## Required Dealer Action

1. Verify that vehicle is part of Recall 0185.
  - a. See instructions in Vehicles Affected.
2. Remove left saddlebag. See service manual.
3. Remove left side cover. See service manual.
4. Remove main fuse. See service manual.
5. Remove dash panel. See service manual.

Figure 1. Install Steering Ballast

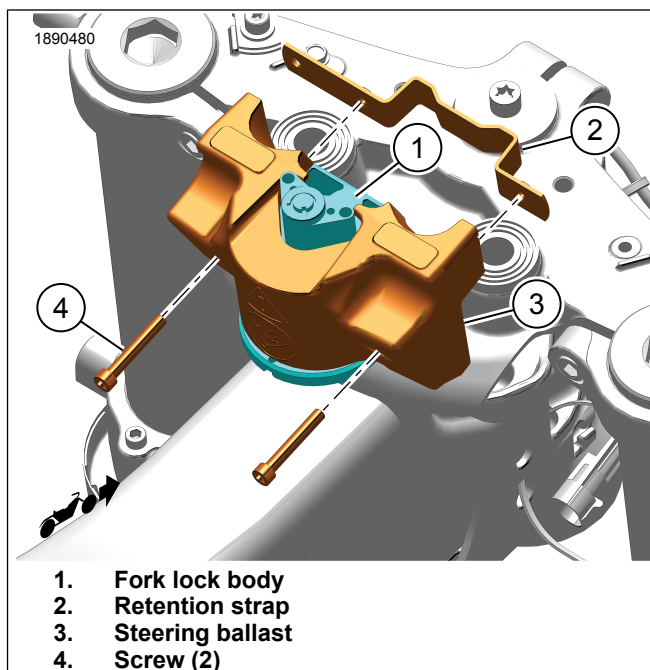
1. See Figure 1. Install steering ballast (3) over fork lock body (1).
  - a. See Figure 2. Verify upper and lower retention features (1 and 3) are positioned properly.
2. See Figure 1. Install retention strap (2) in front of fork lock body (1).
3. Install screws (4). Tighten.  
Torque: 4–4.8 N·m (35–42 in-lbs)
